# ADDENDUM NO. 3

### November 28, 2022

# JACKSON ELEMENTARY SCHOOL RENOVATIONS Valparaiso, IN 46304

This Addendum consists of page ADD 3-1 and attached Addendum No. 3 from Gibraltar Design dated November 23, 2022 and consisting of 7 pages and 42 drawings.

©GIBRALTAR DESIGN SHEET ED101

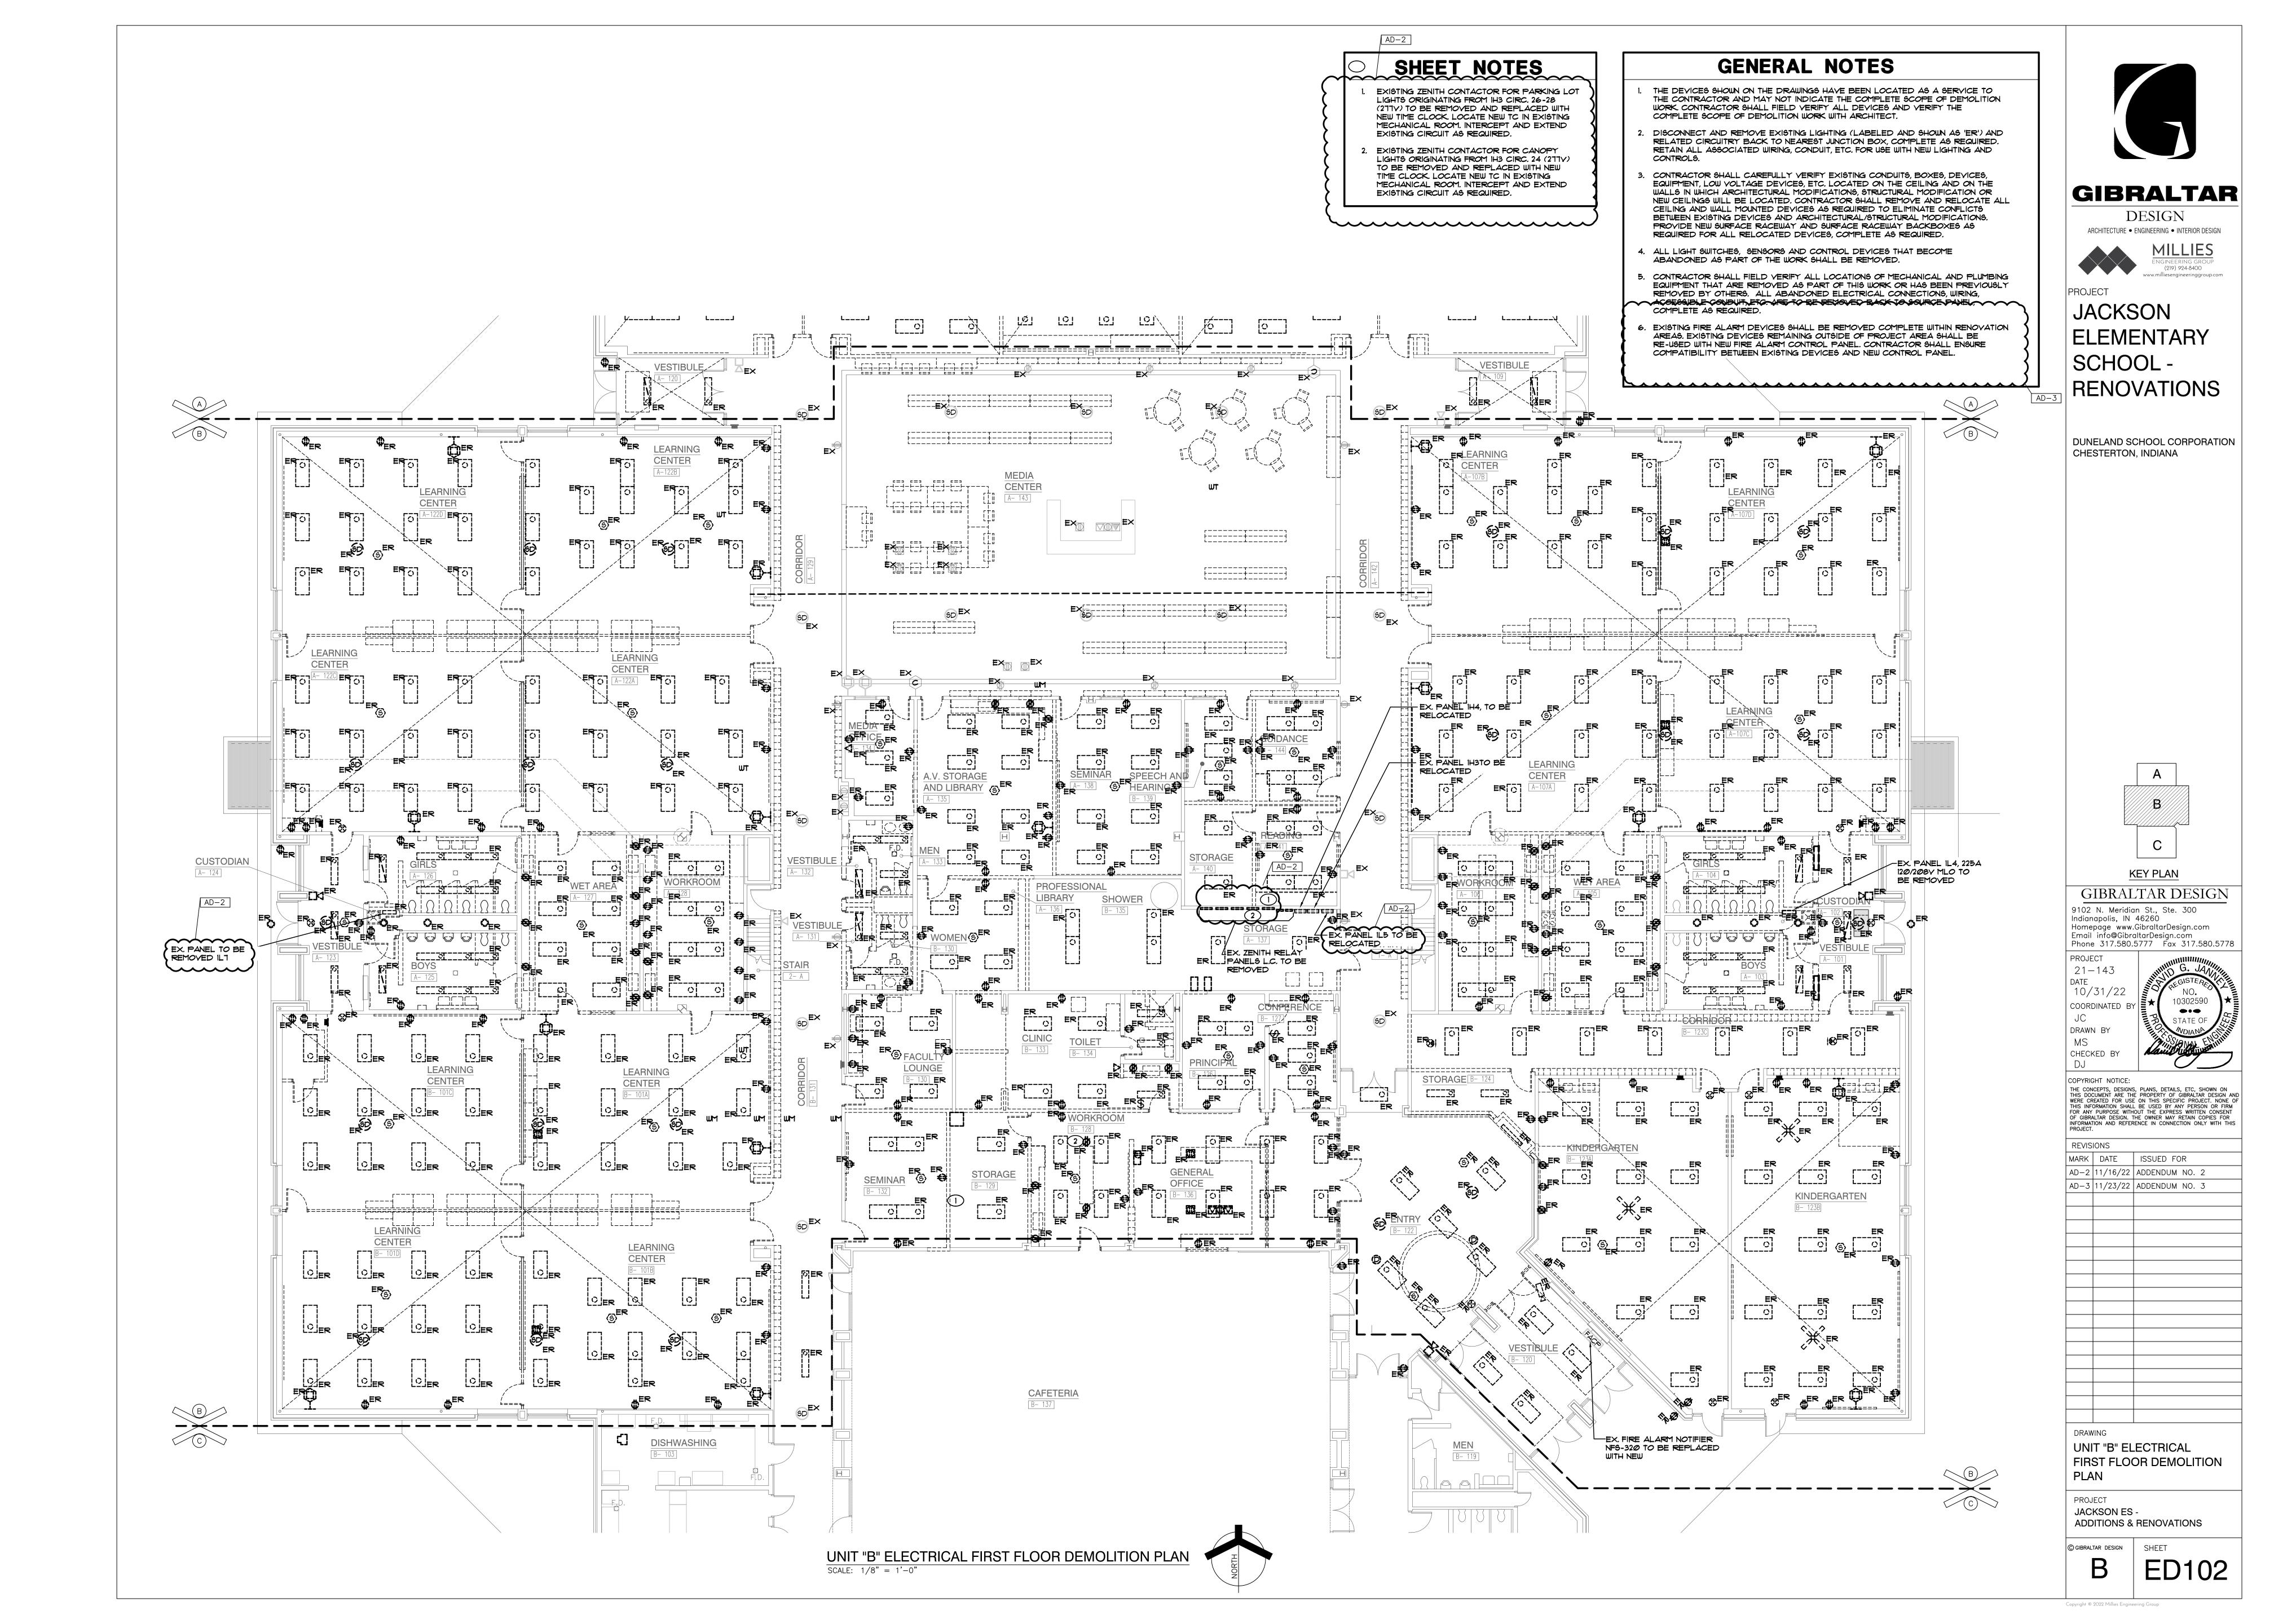
- A. Refer to revised full size drawing, included in this Addendum, for the following revisions:
  - 1. Added General Sheet Note #6.
  - 2. Added panel name to 1L6.

SHEET ED103

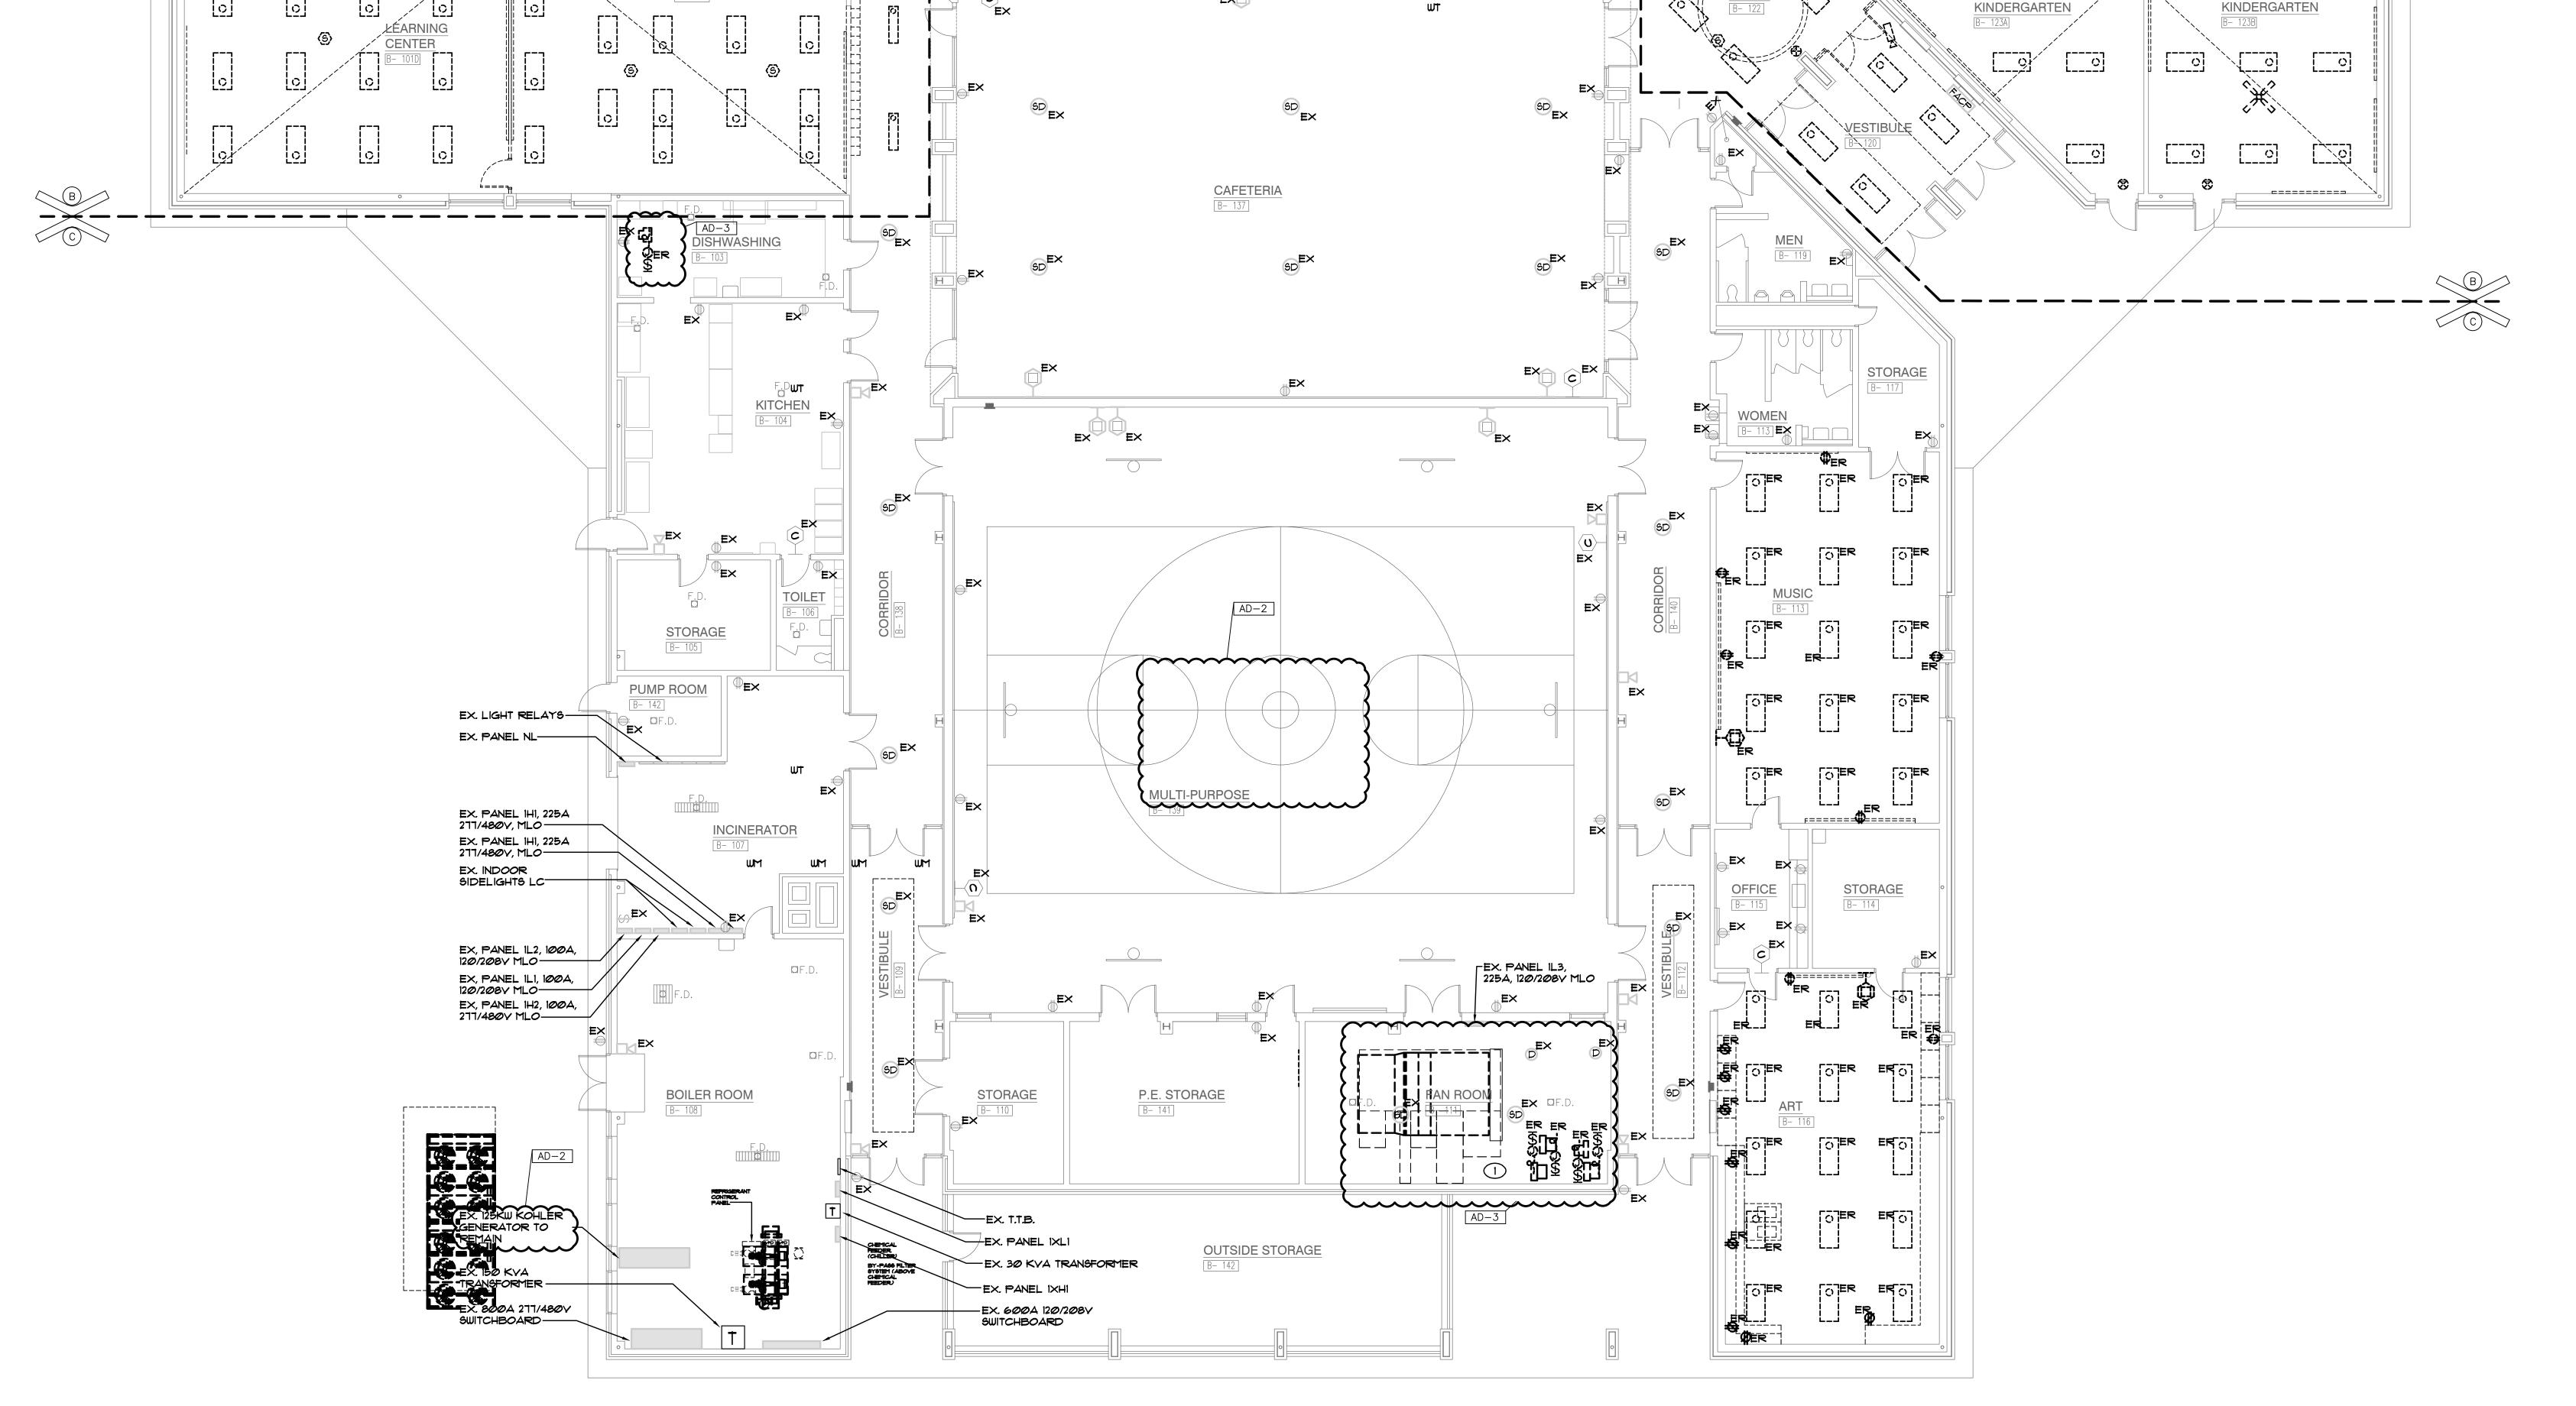
- A. Refer to revised full size drawing, included in this Addendum, for the following revisions:
  - 1. Added General Sheet Note #6.
  - 2. Added demo power connections for mechanical equipment.

© GIBRALTAR DESIGN SHEET EL101 Α

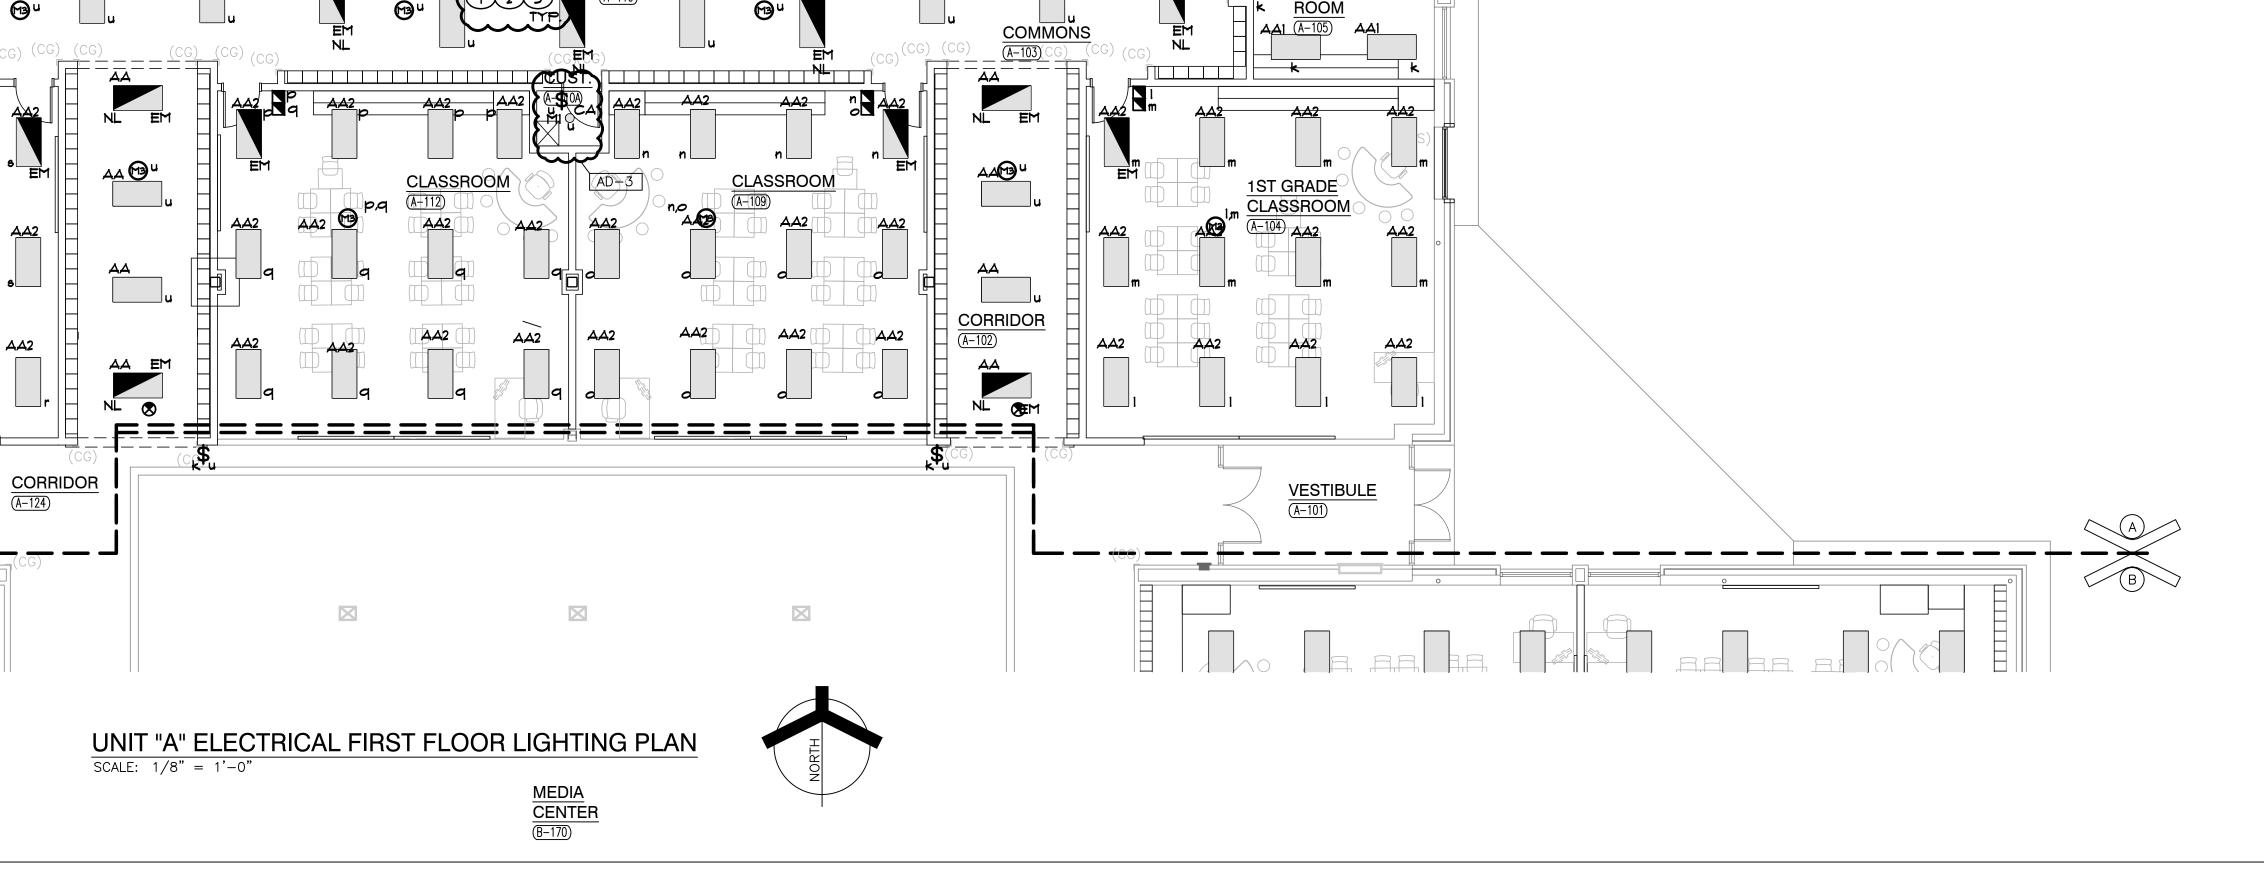
A. Refer to revised full size drawing, included in this Addendum, for light added to closet.
